# City of Grand Forks Staff Report

**Agenda Item: 4-1 (Preliminary)** Matter of the request from Taney Engineering, on behalf of Promenade Partners, LLC, for preliminary approval of the Replat of Lots 1-15 and Lots 28-43, Block 1 and All of Block 2, Promenade Third Resubdivision, to the City of Grand Forks, ND, located at Thames Court and 8<sup>th</sup> Avenue North.

PROMENADE THIRD RESUBDIVISION  
 REPLAT OF LOTS 1-15 AND LOTS 28-43, BLOCK 1  
 AND ALL OF BLOCK 2

ITEM NO. 4-1  
 MEETING DATE: 8/6/2014  
 REVIEW DATE: 7/23/2014

- Preliminary plat
- Technical change sheet

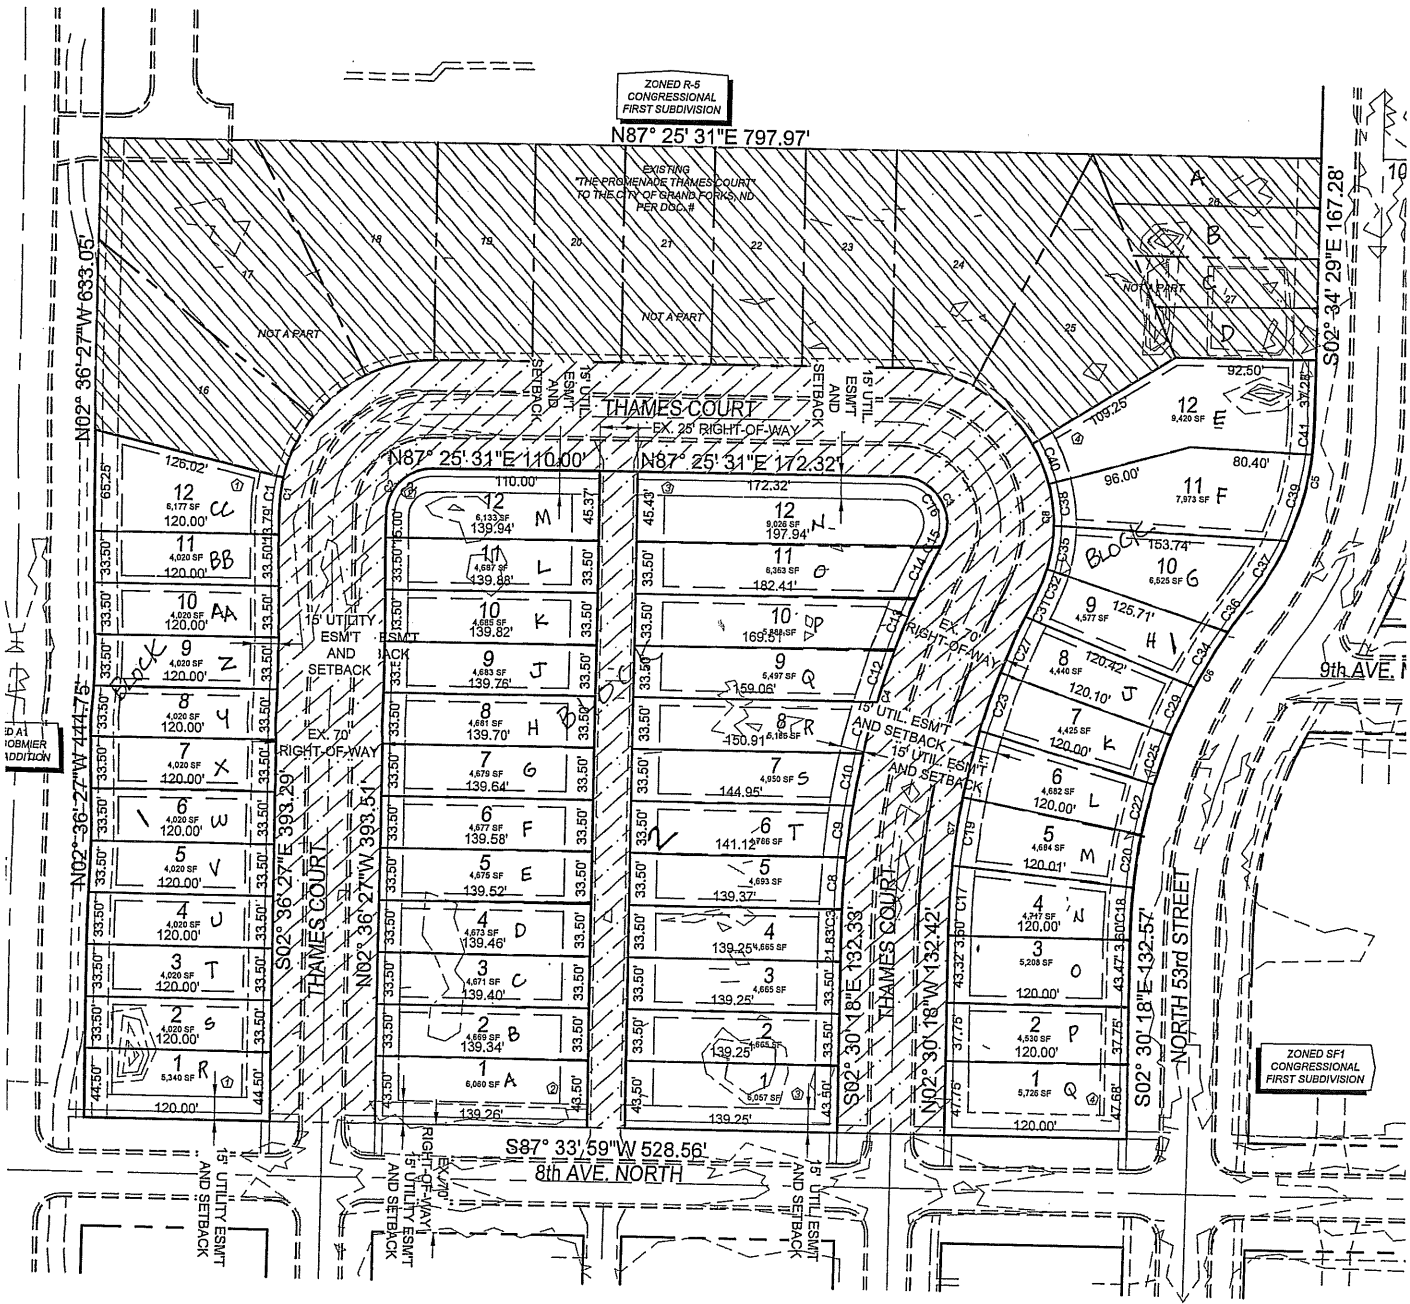
1. Submit title opinion.
2. Drawing scale should be easily recognizable from 1"-100' to 1"-60'.
3. Remove hatching from all lots on the drawing and the rights-of-way.
4. Remove all building setback lines.
5. Show spot ground elevations instead of ground contour lines.
6. Remove all street pavement, sidewalk and driveway lines.
7. Express Delta angles in curve tables in degrees – minutes and seconds.
8. Define a plat boundary.
9. Show bearings and distances for all plat boundary line segments.
10. Set pins at all lot corners.
11. Show pins found.
12. Remove street center lines.
13. Dimension alleyway.
14. Dimension street rights-of-way.
15. Show bearings and distances on all line segments.
16. Show a length on all curved lines.
17. Label all surrounding lands and subdivisions.
18. Show lot and block lines on all adjacent lands.
19. Remove all company logos and affiliations.

20. Remove zoning references.
21. Revise legend accordingly.
22. Correctly show replat of Lots 26 and 27, Block 1.
23. Remove building lines.
24. Plat title should read "A Replat of Lots 1-15 and Lots 28-43, Block 1 and all of Block 2, Promenade Third Resubdivision to the City of Grand Forks, North Dakota."
25. Use correct plat title in the owner's consent and dedication.
26. Show existing lots with light dashed lines and dotted text.
27. Include and label all existing utility easements
28. Add access control along North 55<sup>th</sup> Street.
29. Submit utility master plan including water and sewer service locations for all lots.
